## MEMORANDUM

**RE:** Response to Comments  
DEP # 114-1301 – Willow Road Culvert Replacement  
Boxford, MA

This memorandum is in response to comments by MassDEP regarding the NOI Submission for the proposed culvert replacement on Willow Road in Boxford, Massachusetts. DEP comments are listed below in ***bold italics***. TEC responses are shown in *italics*.

**CONTROL OF WATER PLAN**  
SCALE: 1" = 5'

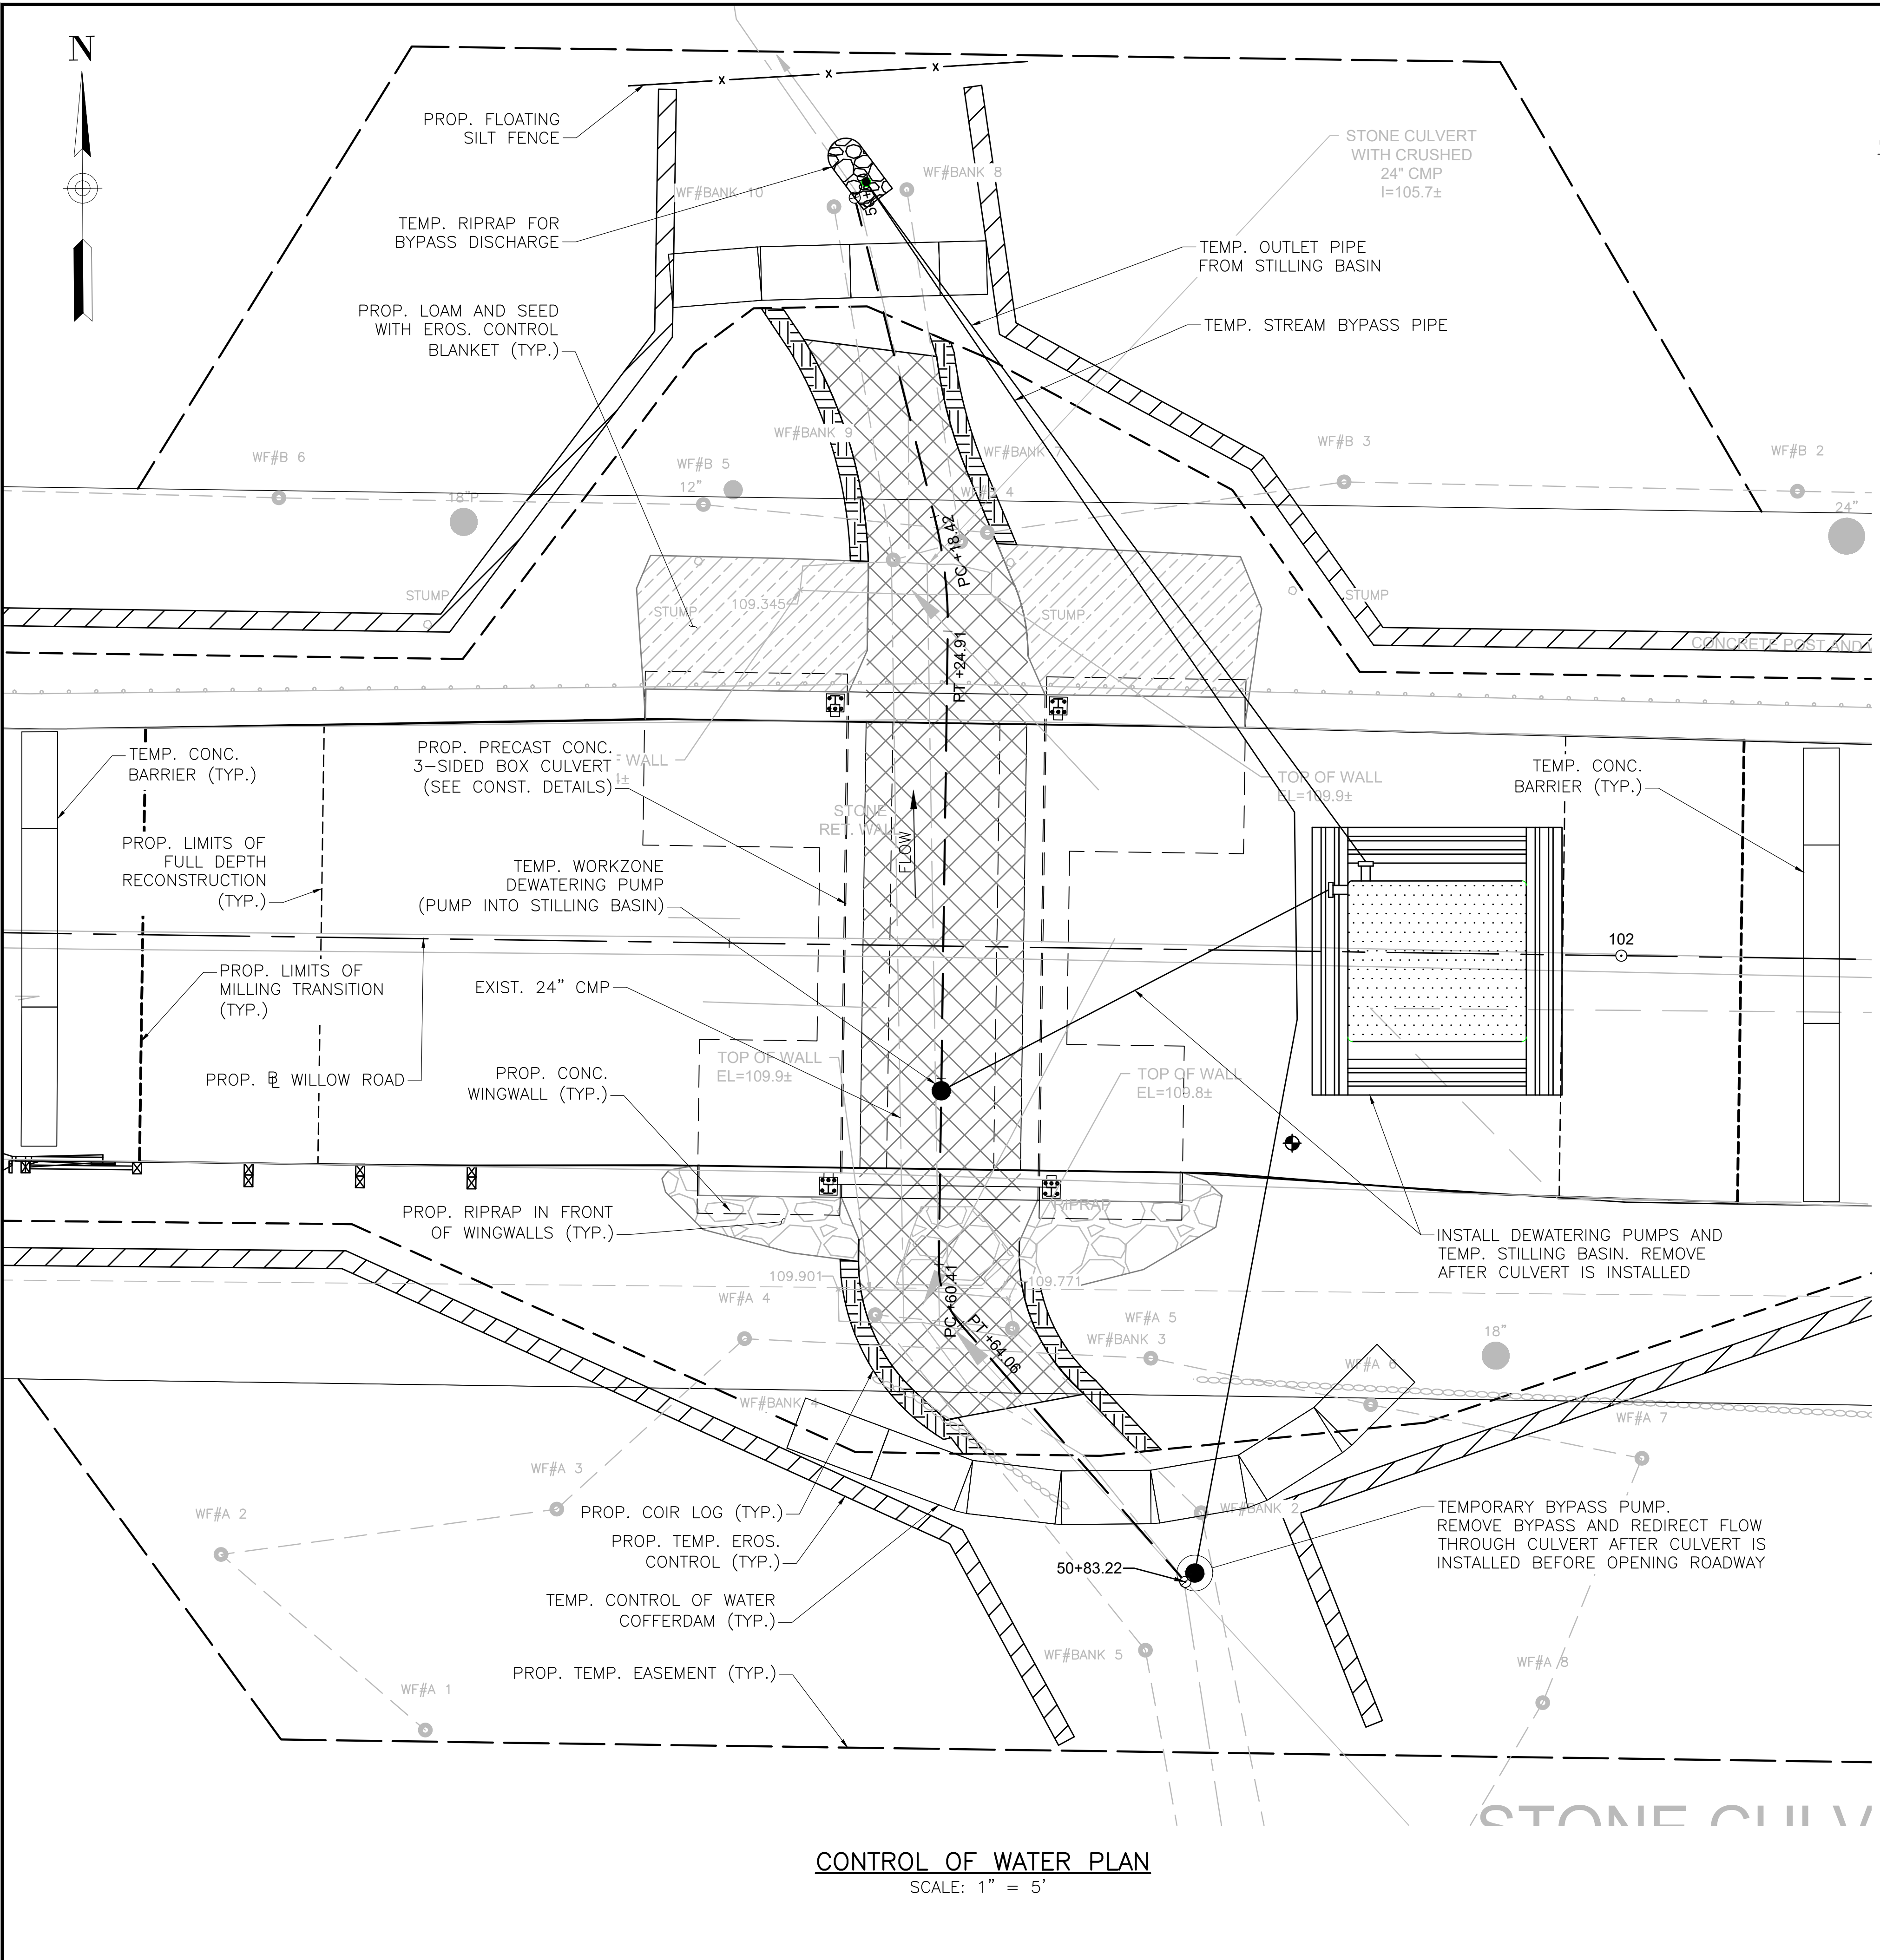
**DEP: A stream bypass should be shown on the plan.**

*TEC: A stream bypass is shown on the Control of Water Plan.*

**RESTORATION PLAN**  
SCALE: 1" = 10'

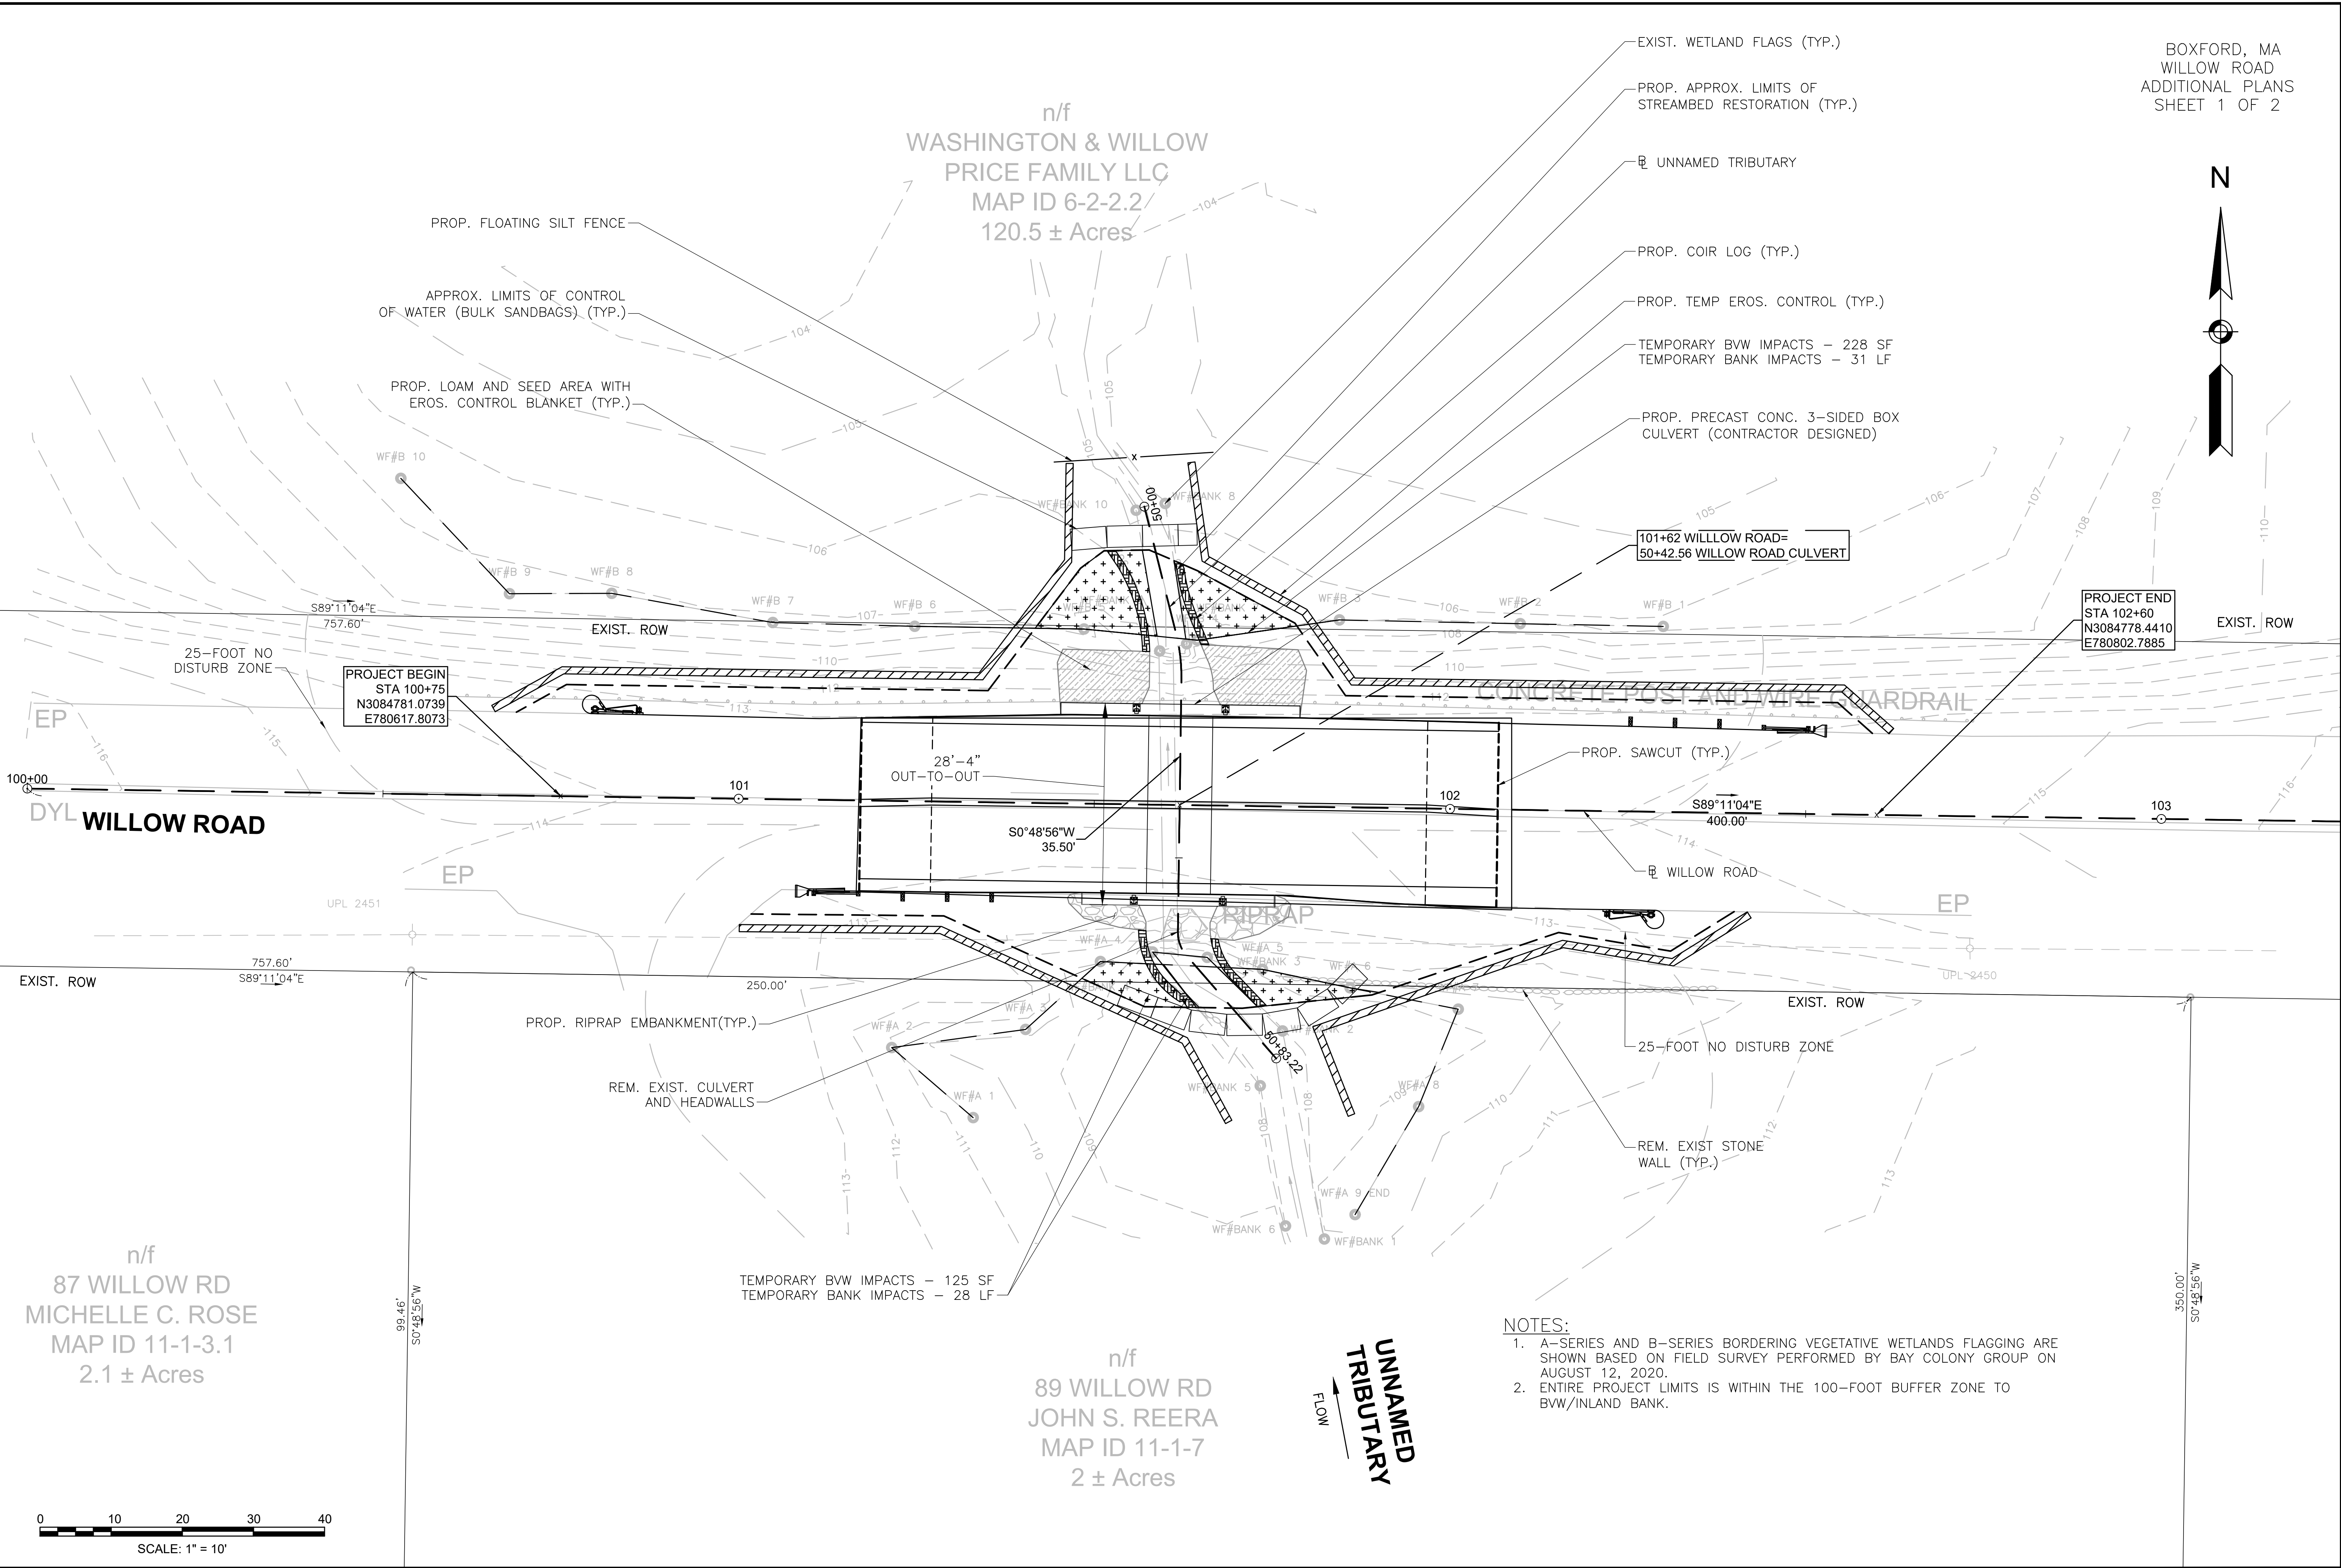
**DEP: Restoration to Bank should be revised to include appropriate sized coir logs secured by wooden stakes, and planted with live stakes and/or tubelings. A planting plans should be provided that describes how the BVW areas will be restored. The planting plan should include the species, quantity and height along with a seed mix.**

**TEC: The coir logs, and their associated details, have been added to the plan set and can be seen on Sheets 1, 3, 4, 7, 8 and Additional Plans 1 & 2. A Restoration Plan has been added at the end of the plan set (Additional Plan 2) and includes the plantings requested.**
